K-18-000533 K1 041909 3/28/2022

City of Fitchburg  
Planning/Zoning Department  
5520 Lacy Road  
Fitchburg, WI 53711  
(608-270-4200)

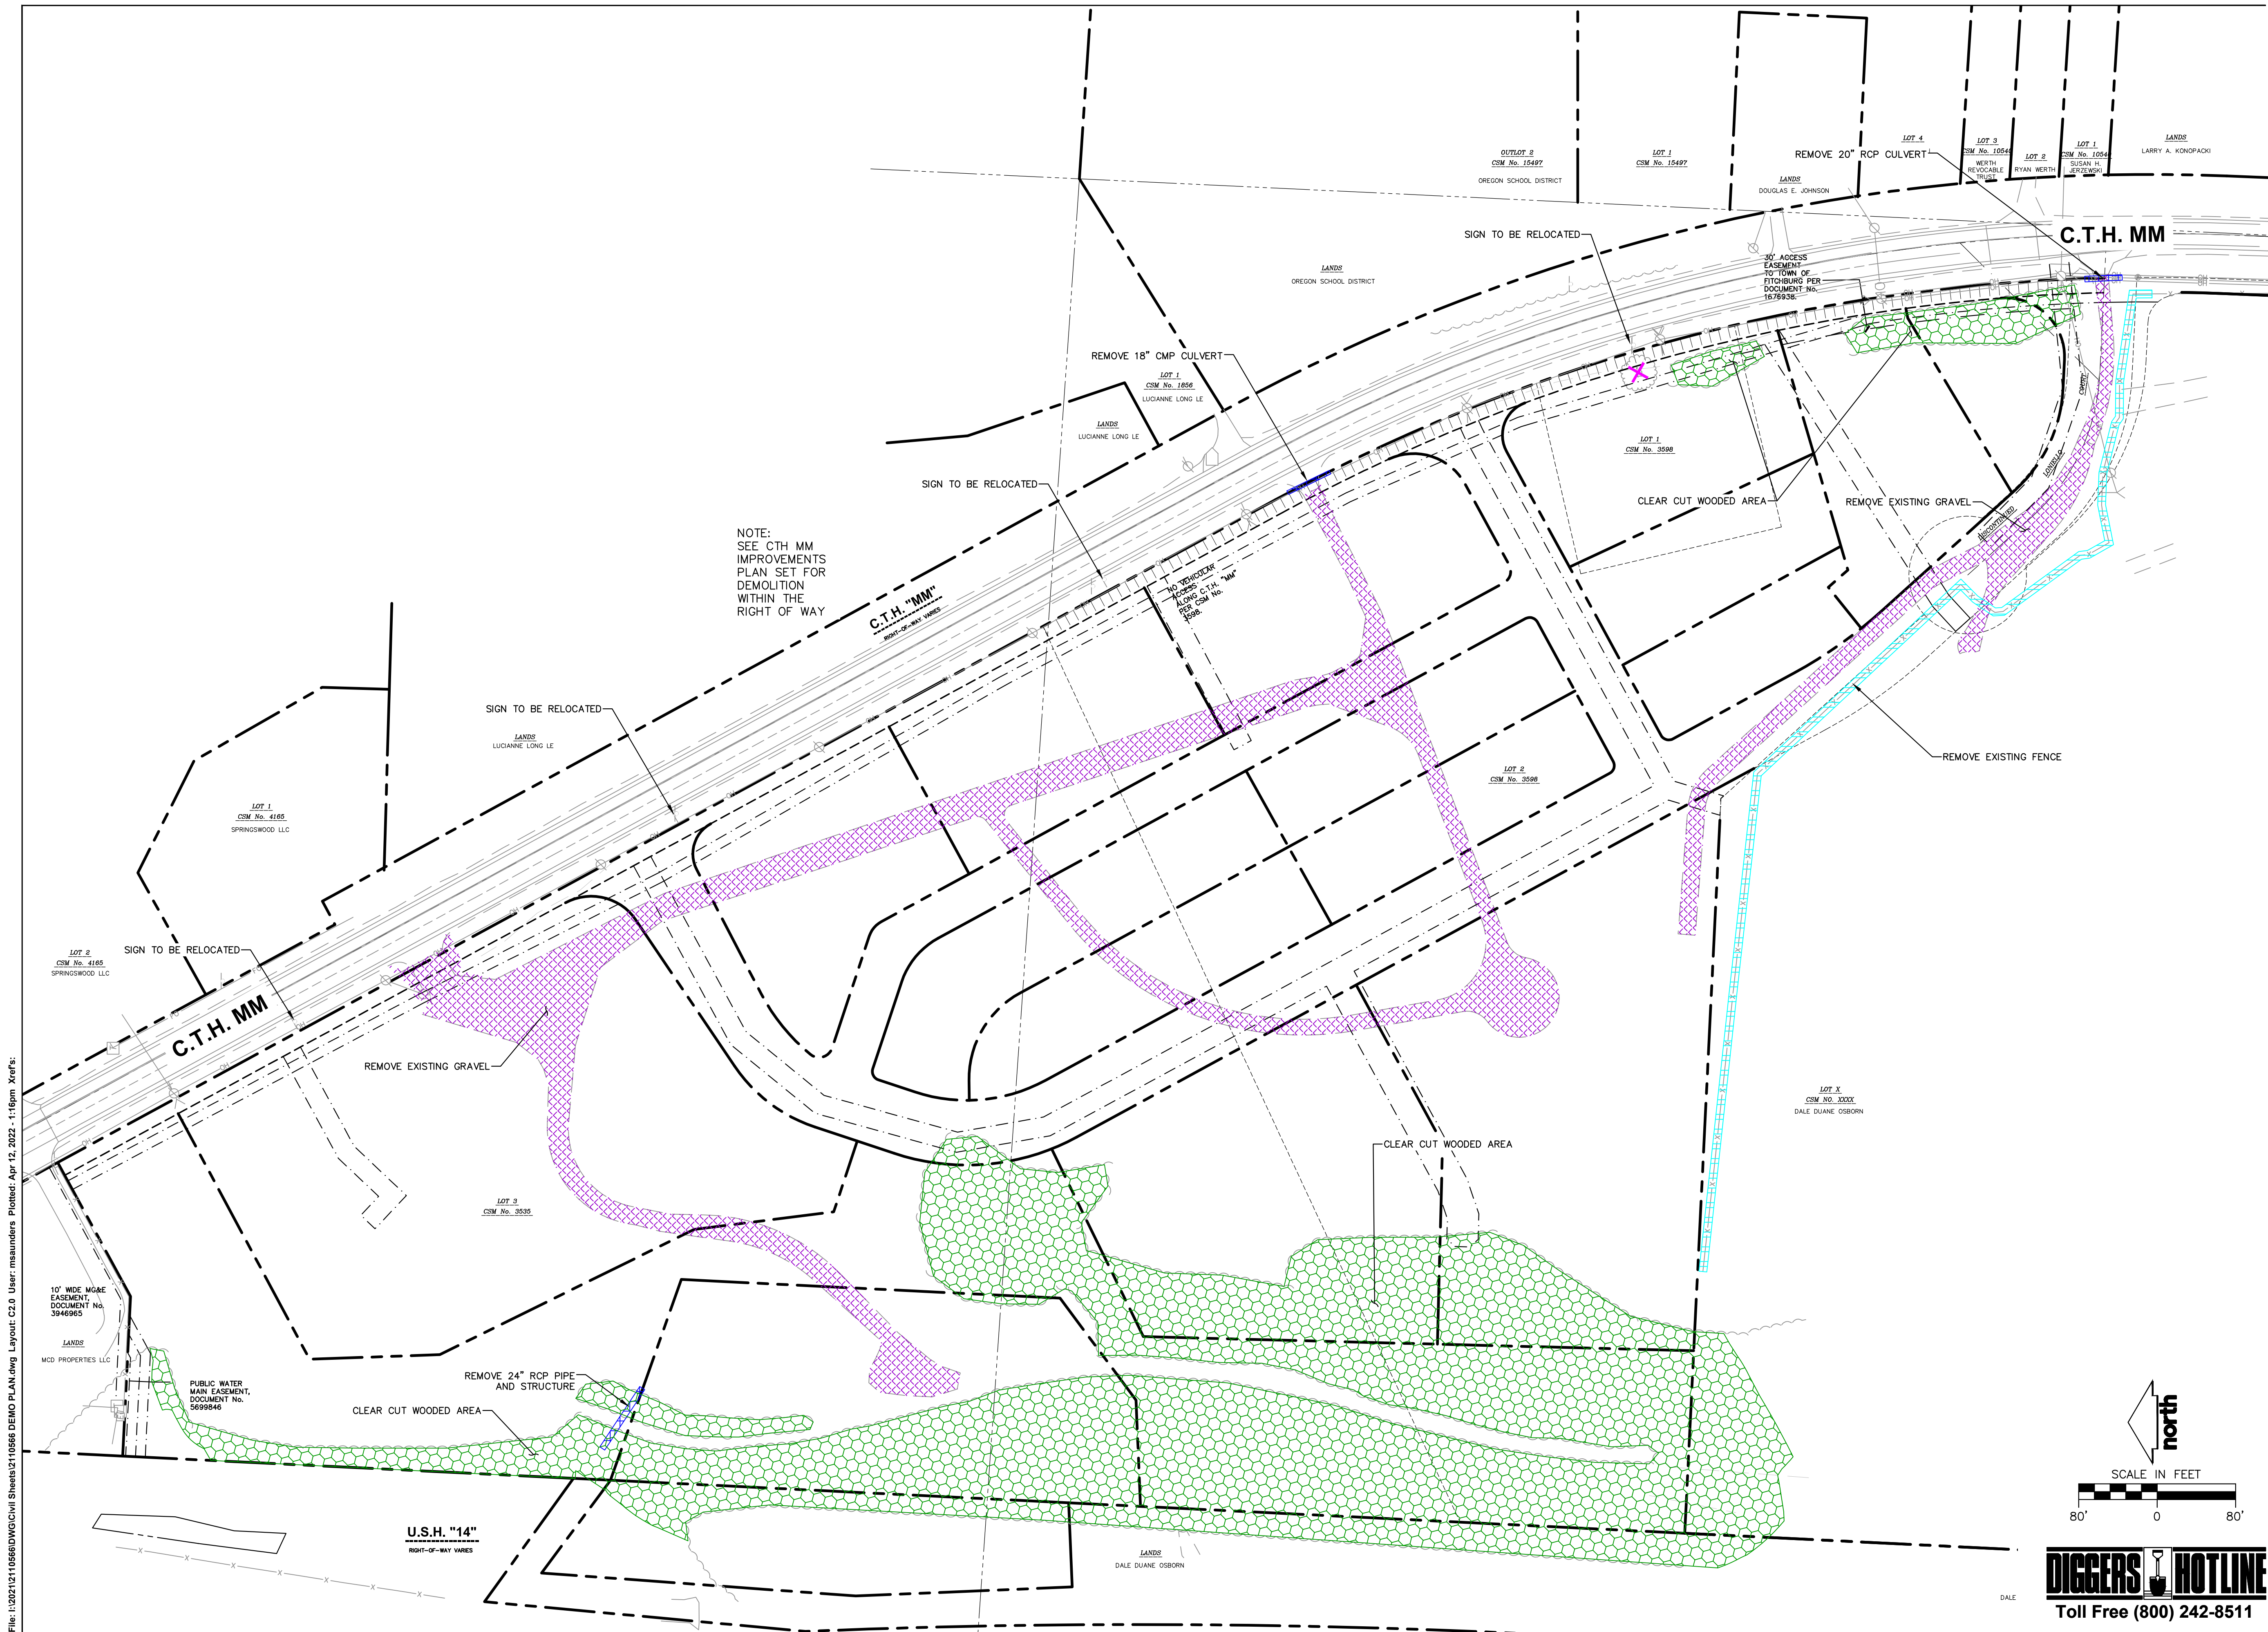
#	Date:	Description:
1	03.25.22	P-PLAT SUBMITTAL
2	04.12.22	RESPONSE TO P-PLAT COMMENTS
3		
4		
5		
6		
7		
8		
9		
10		
11		
12		
13		
14		
15

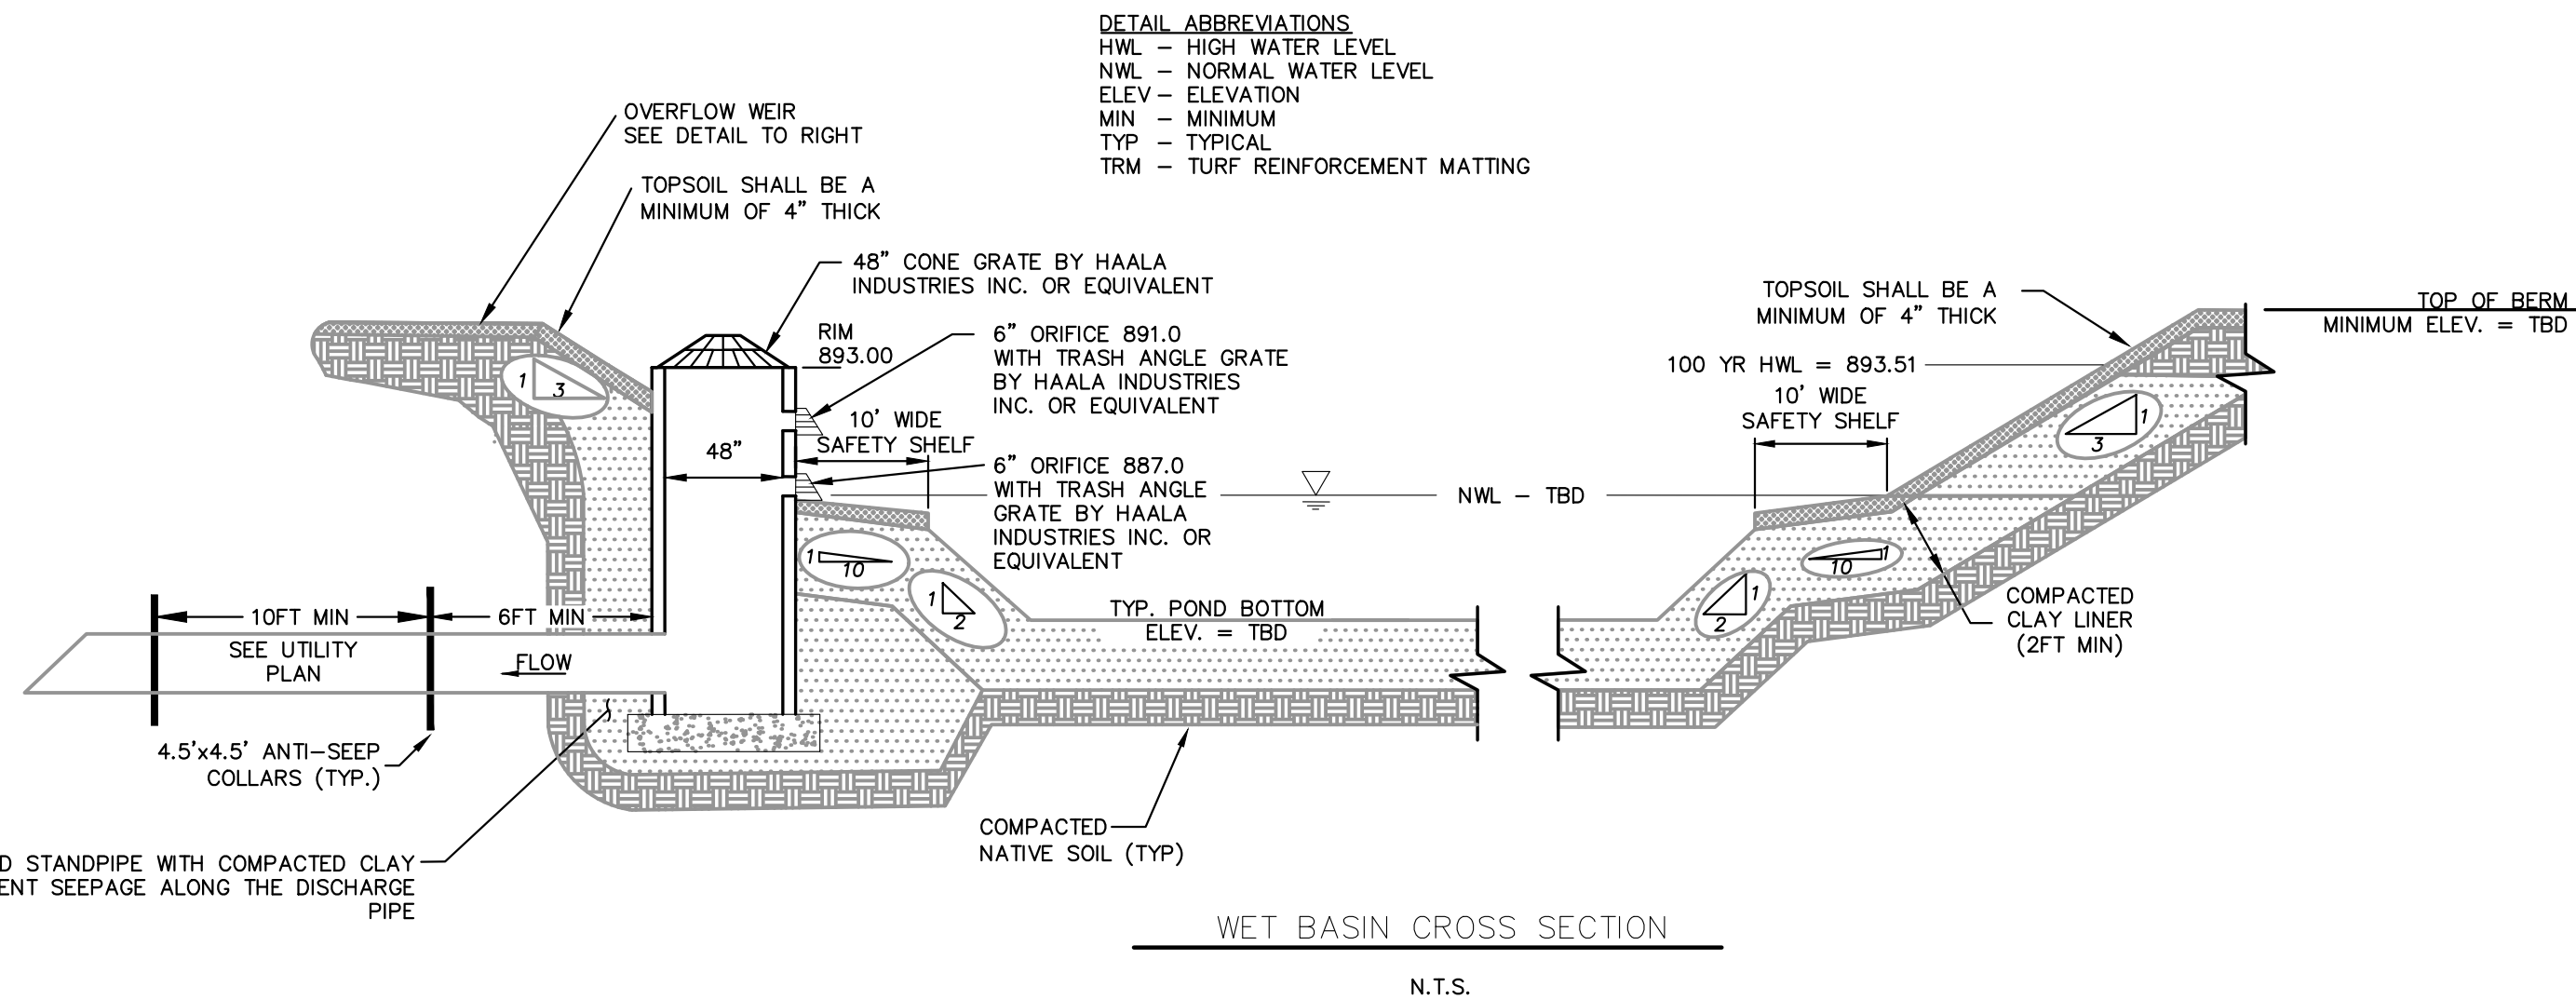
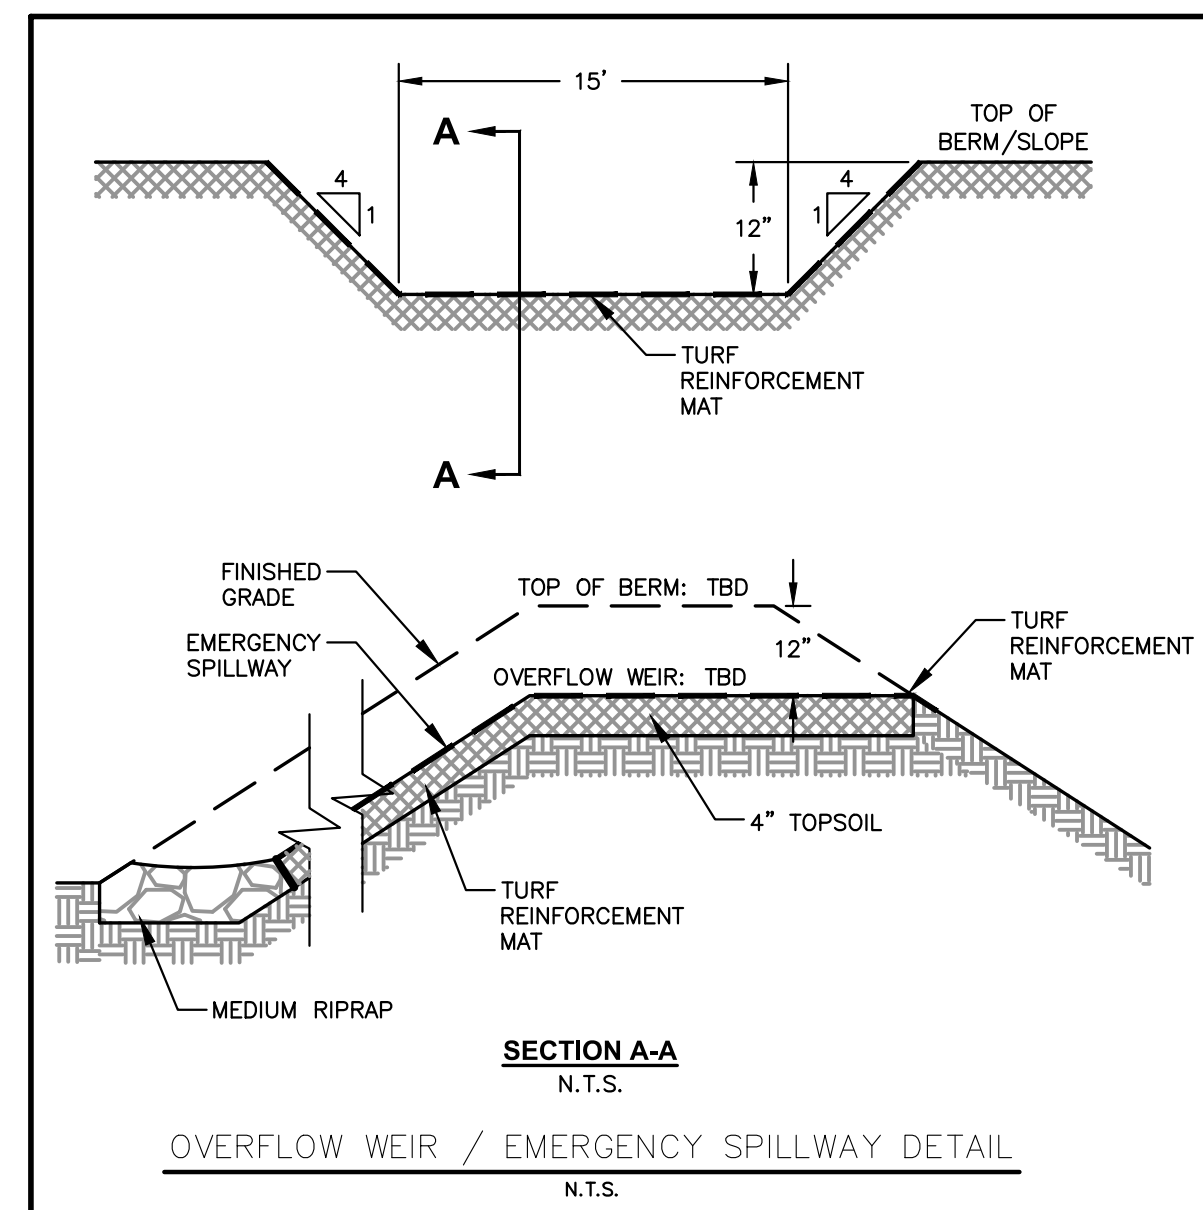
#	Date:	Description:
1	03.25.22	P-PLAT SUBMITTAL
2	04.12.22	RESPONSE TO P-PLAT COMMENTS
3		
4		
5		
6		
7		
8		
9		
10		
11		
12		
13		
14		
15
